ADDENDUM NO. 2

NIKE, INC.

NIKE RETAIL

LENOX SQUARE MALL - ATLANTA, GA

P2.02

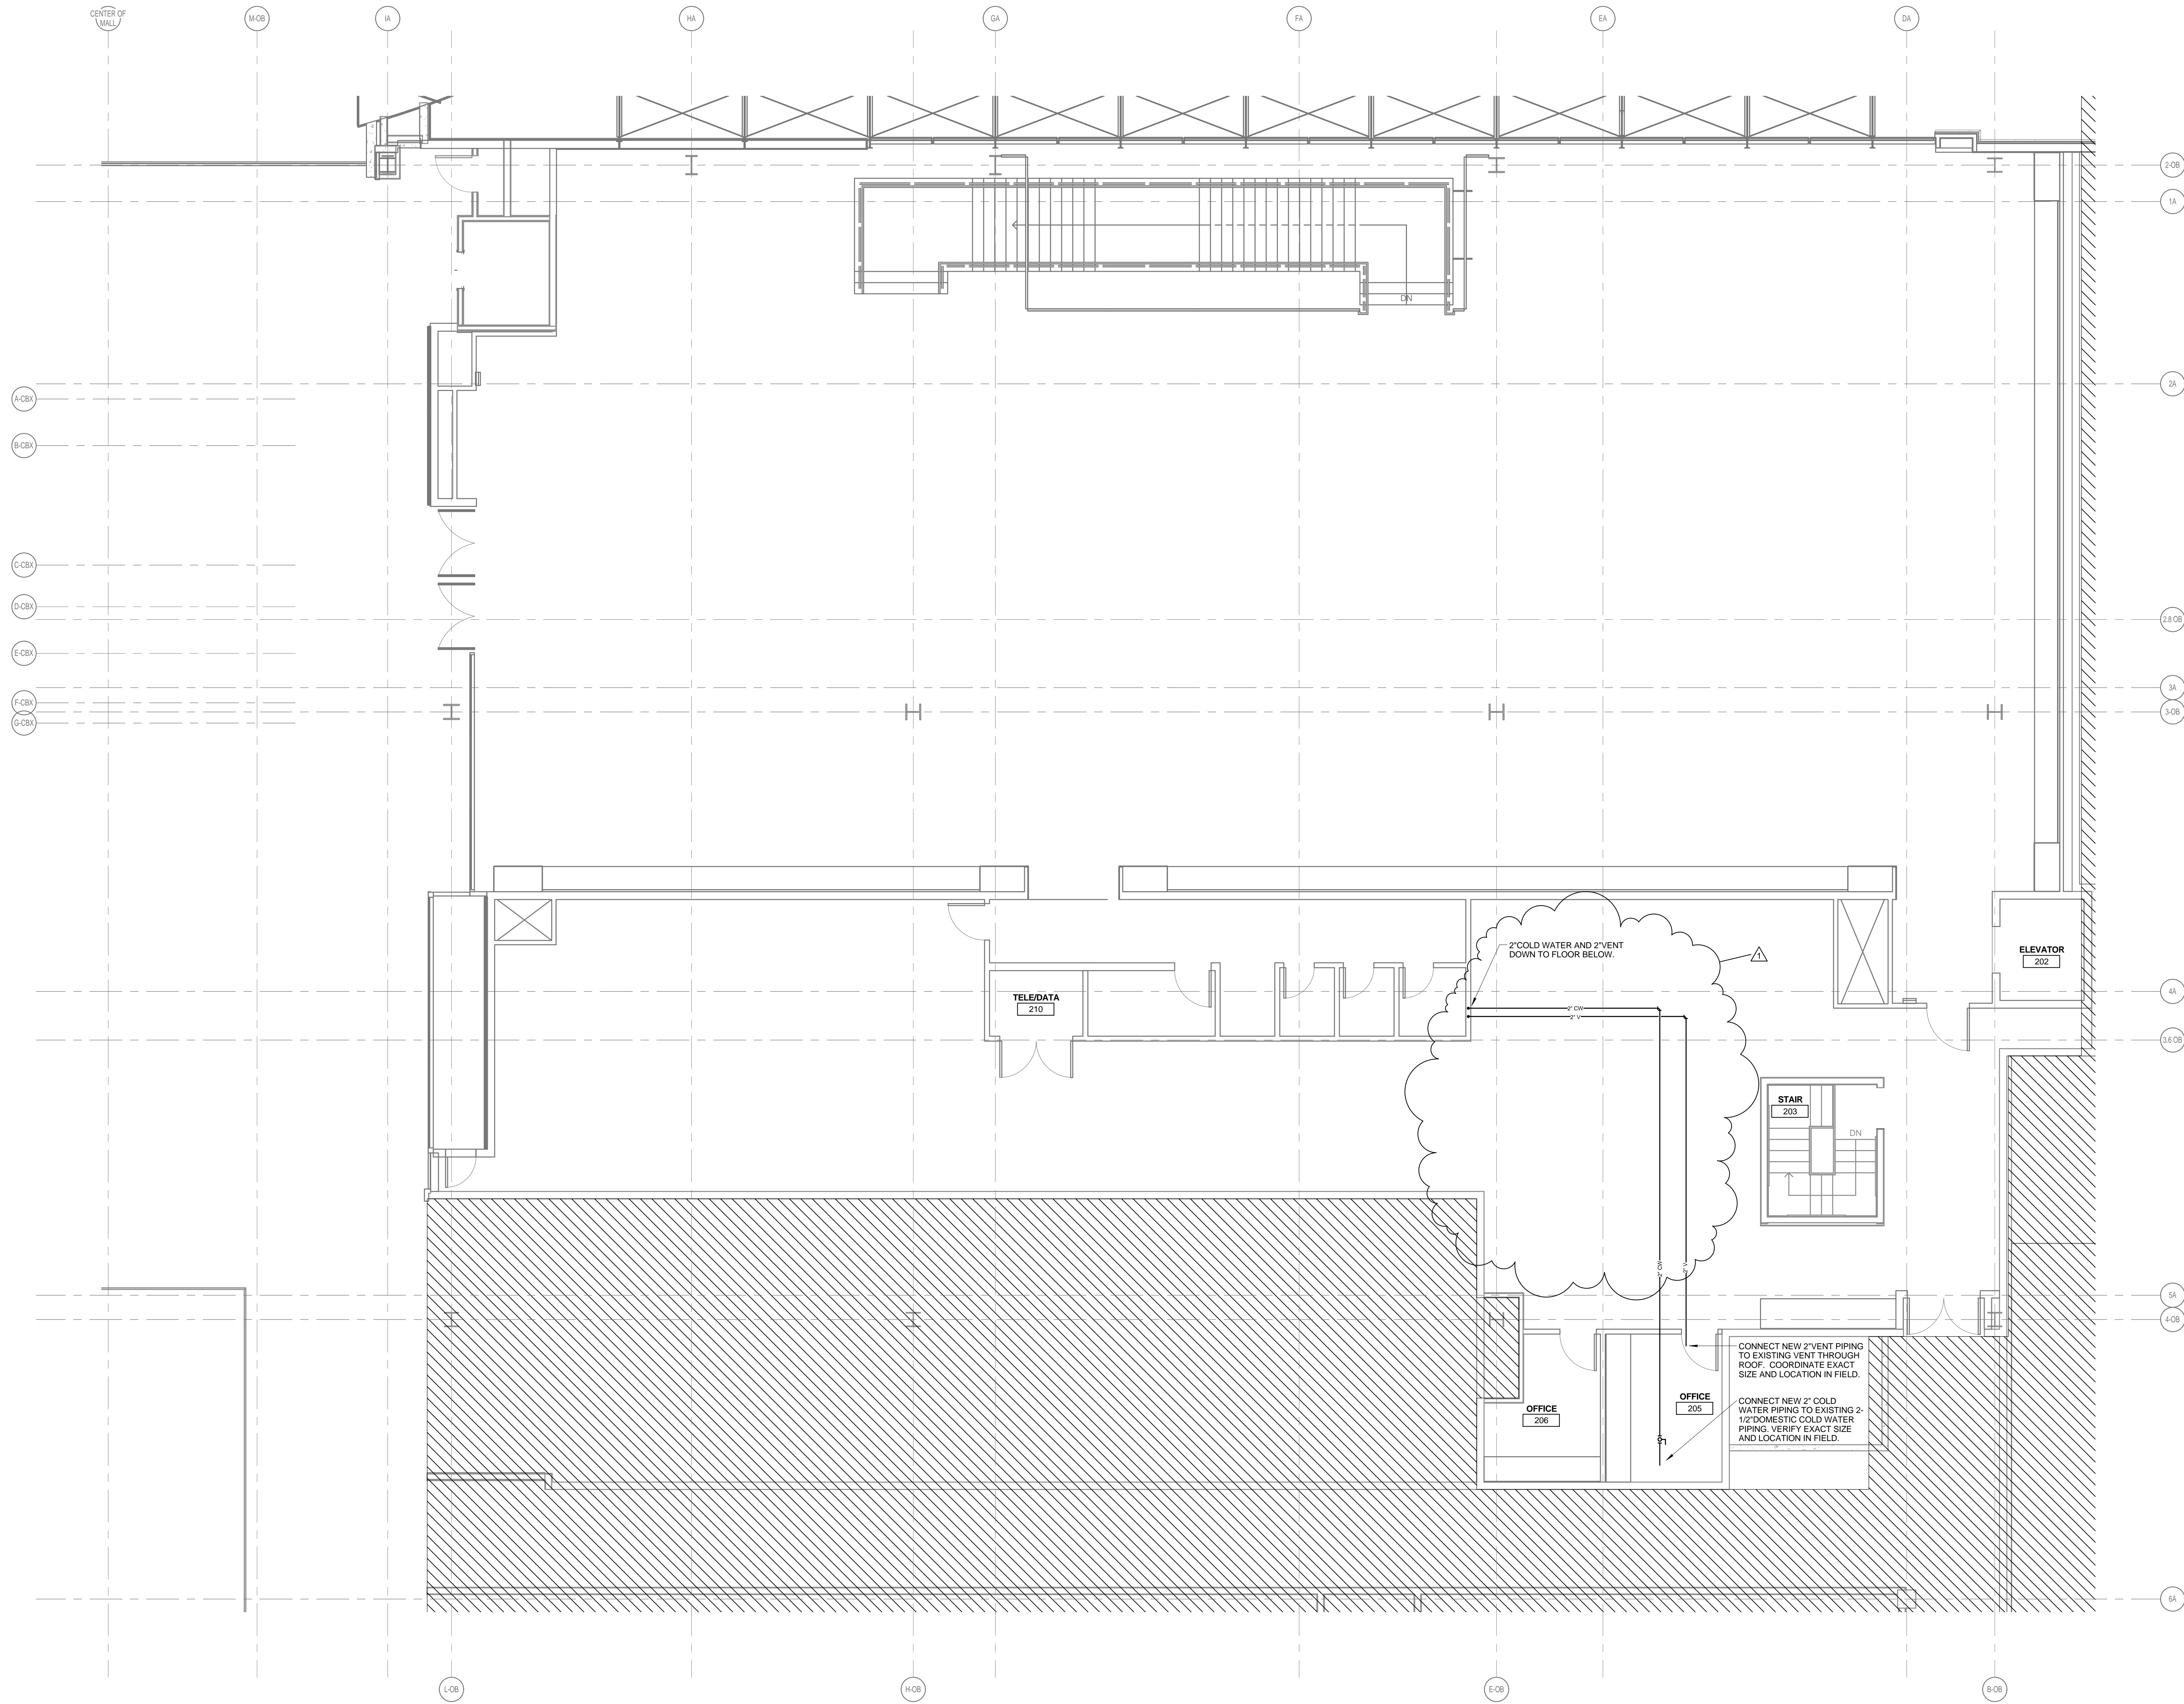
1.22 P2.02
Add: Revised location of Cold water and Vent stack to first floor.
